Date:	April 5, 2011	
То:	Tammie Keplinger Charlotte-Mecklenburg Planning Department	
From:	Michael A. Davis, PE <i>Mike Units</i> Development Services Division	
Subject:	Rezoning Petition 11-023:	102.40 Acres located near the north side of the intersection of Brooks Mill Road and Albemarle Road

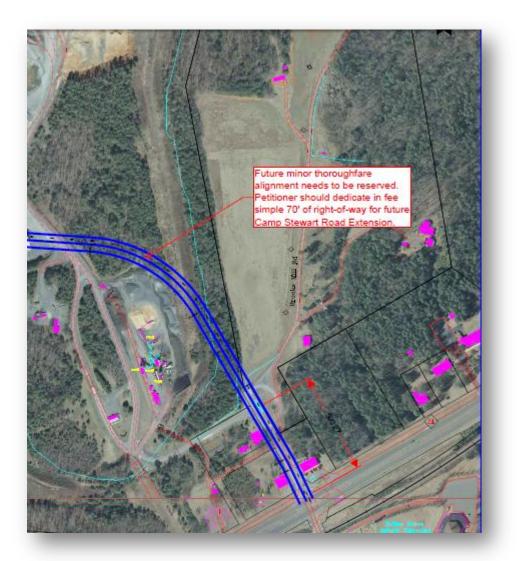
1. The Mecklenburg Union Metropolitan Planning Organization (MUMPO) Thoroughfare Plan identifies a future minor thoroughfare that traverses the site. We recommend the petitioner contact Mr. Stuart Basham of MUMPO at 704-336-4695 to obtain the correct alignment (see the below image depicting Camp Stewart Road Extension's conceptual alignment). The revised site plan should show the future curbline and right-of-way, including any additional embankment needs due to the existing quarry's topographic conditions, and any proposed site access driveways from the MUMPO alignment in order for us to continue our review of the petition. We recommend the right-of-way for the future thoroughfare be dedicated and conveyed in fee-simple.
